Report of Second EDS Reply

Subject- Letter issued by Divisional Forest Officer, Forest Department Aurangabad. Dtd-17/02/2022
(जा. क्र.ब/कक्ष ०७/वि व अ/ व जी औ/सर्वे/3152/2021-22) .

Reference: Proposal of Brahmagavhan Lift Irrigation Scheme – III, for approval of wildlife clearance. Proposal No.FP/MH/IRRIG/5828/2021.

Name of the project - Brahmagavhan Lift Irrigation Scheme – III, Near Old Lakhmapur village,
Tal. Gangapur, Dist. Aurangabad.

GOOGLE MAP FOR
BRAMHAGAVHAN LIFT IRRIGATION SCHEME PART-III

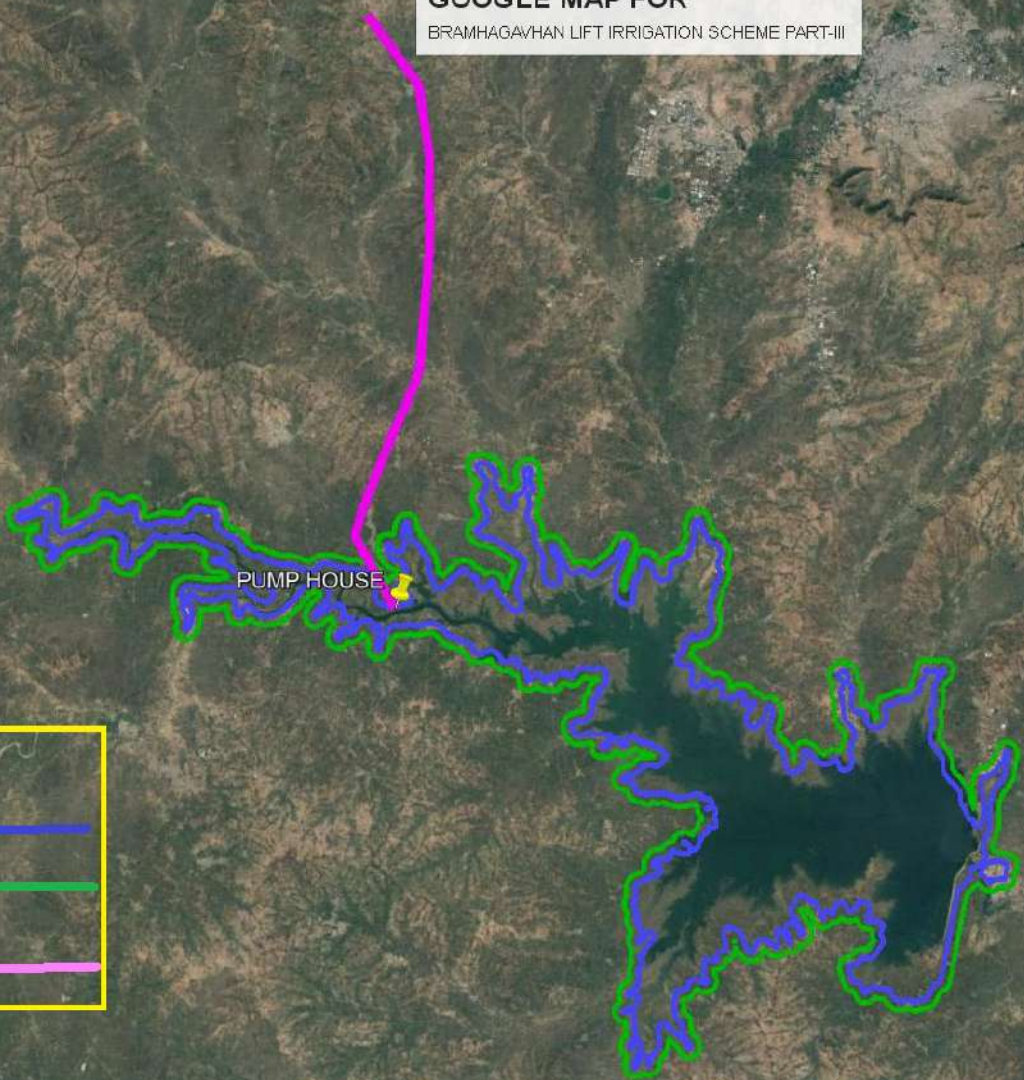
9	Point No. C- (v) Does not marked the boundary of Jayakwadi Bird Sanctuary on Geo-referenced map?	The Geo referenced map marking boundaries of Jayakwadi Bird Sanctuary has been attached herewith as enclosure 3.
10	Point No. D- The Justification for locating the project in protected area was submitted without signature of the authority person?	The copy of signed justification for locating the project in protected area has been attached herewith as enclosure 4.
11	Point No. D- (a) Reason for not providing such map?	The signed copy of Justification is submitted herewith. There is no need to do survey for alternative location. Hence, does not require submitting any map with application.
12	Point No. H-2 (a) The Copy of the Bio-diversity Impact Assessment report has not been submitted with the application?	With reference to Point H-2 in the Wild Report (Part-I & II) stated that the Bio-diversity Impact Assessment report does not required to such proposals which contains an area below to 50 hectares area.

**JAIKWADI BIRD WILDLIFE SANCTUARY
 TOPOSHEET MAP SHOWING THE
 BRAMHAGAVHAN LIFE IRRIGATION SCHEME PART-III**

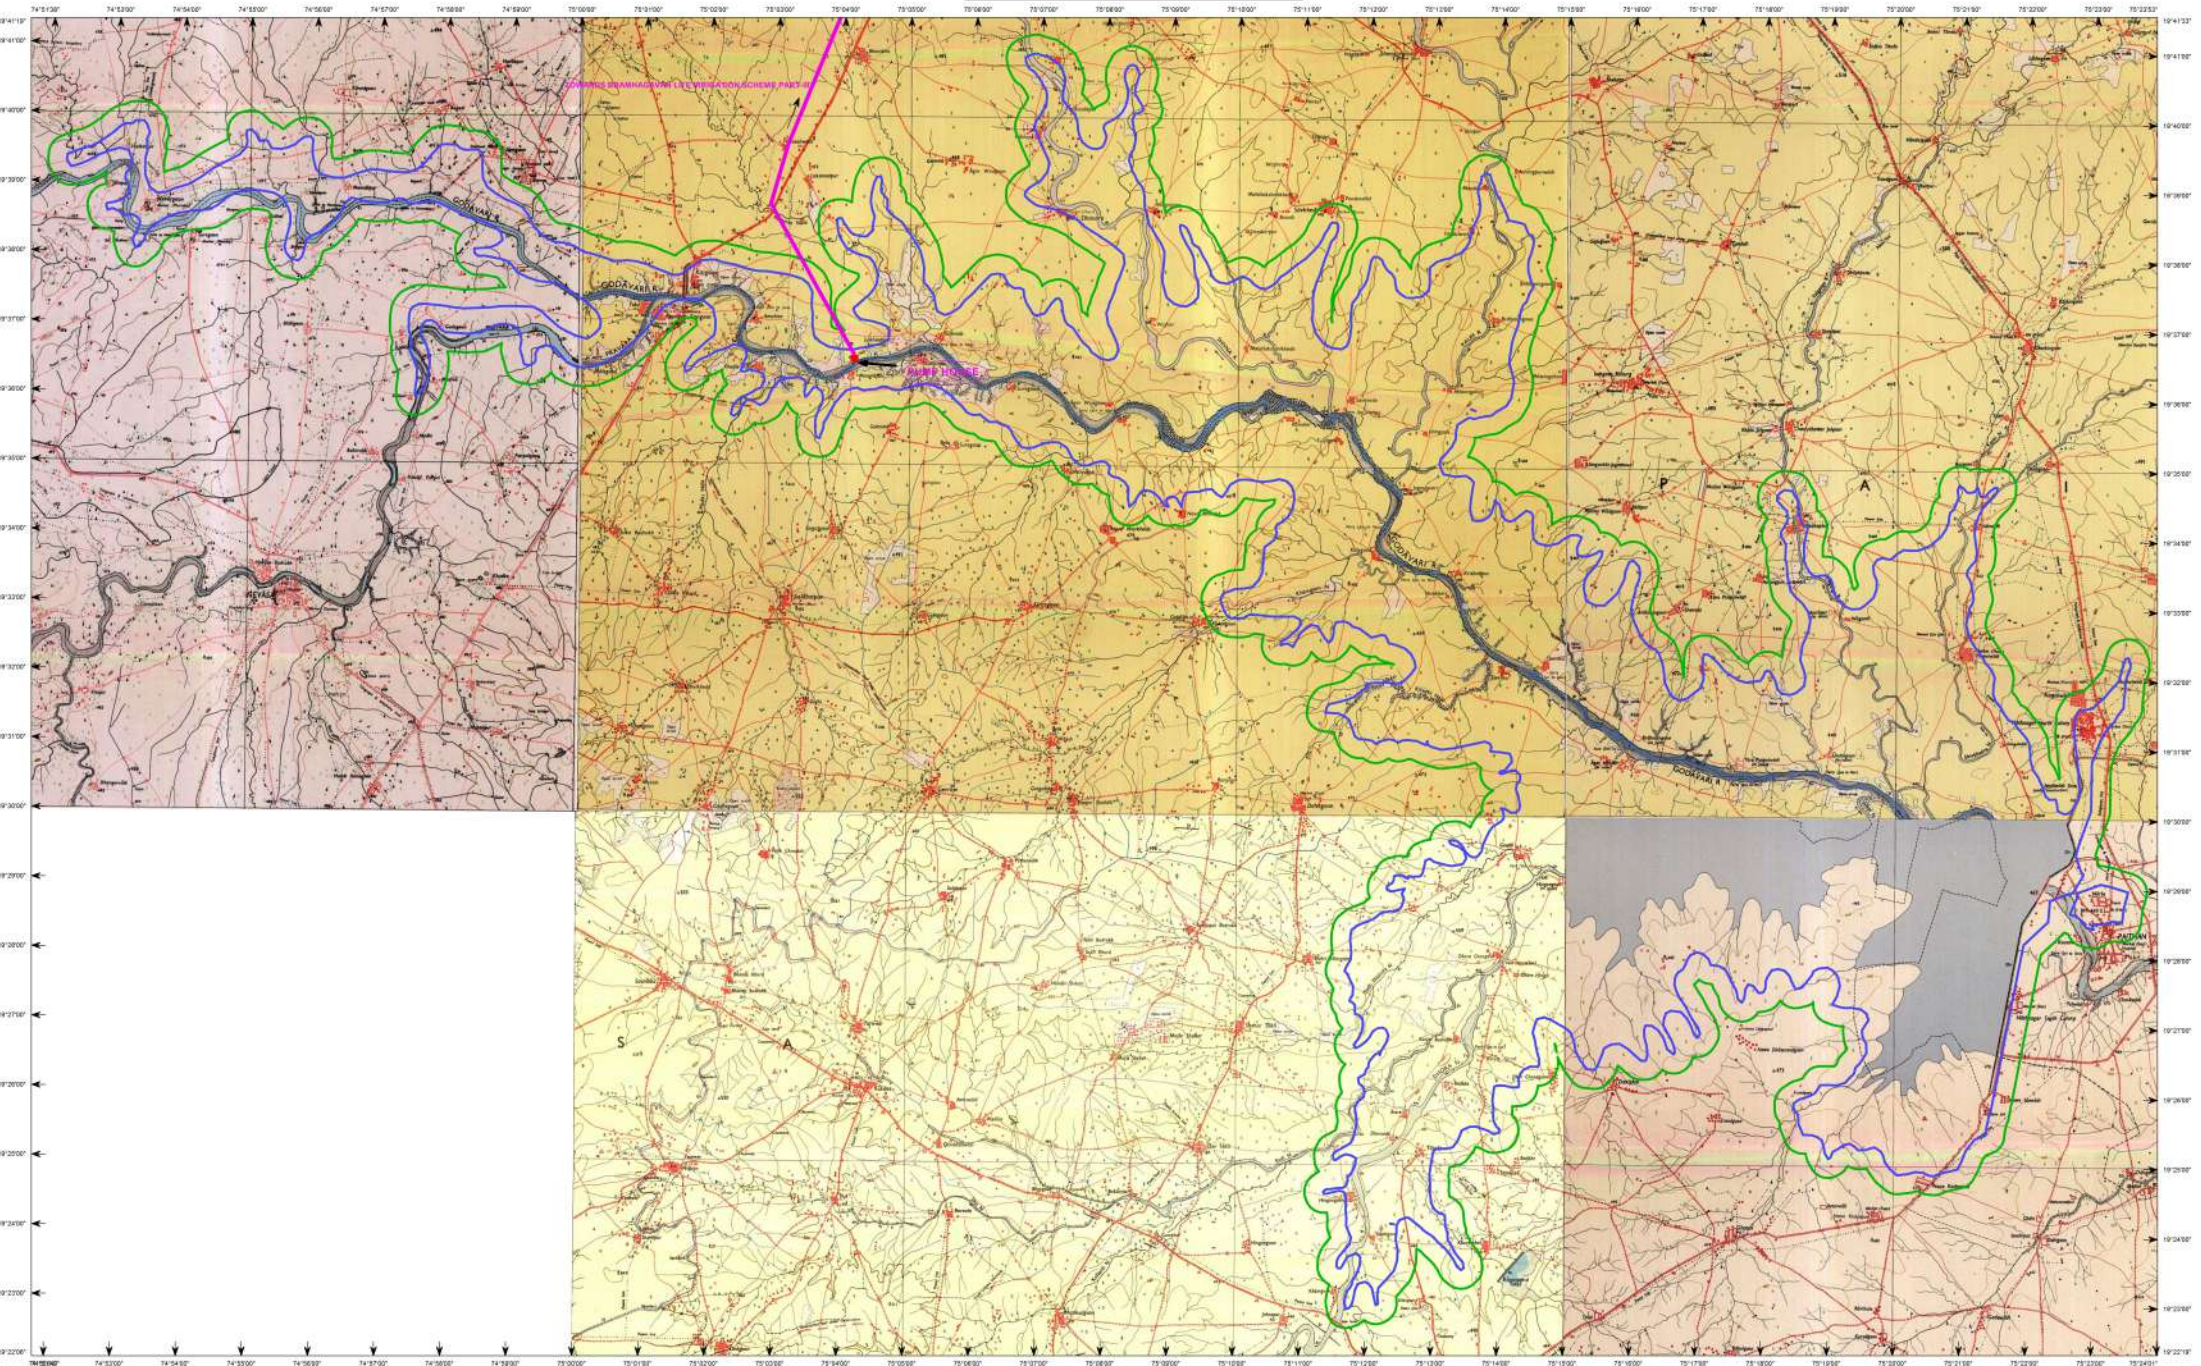
Sr No.	Component	Project area under Protected Area (PA) in ha.	Project area under Non Protected Area in ha.	1	Pump House-1	1	0	2	Pump House-2	0	1	3	Delivery Chamber	0	1	4	Rising Main	0.34	0
Sr No.	Component	Project area under Protected Area (PA) in ha.	Project area under Non Protected Area in ha.																			
1	Pump House-1	1	0																			
2	Pump House-2	0	1																			
3	Delivery Chamber	0	1																			
4	Rising Main	0.34	0																			
8	Point No. C- (iv) The boundary of the Jayakwadi Bird Sanctuary does not marked the on Toposheets?	The toposheets marking boundaries of Jayakwadi Bird Sanctuary has been attached herewith as enclosure 2 .
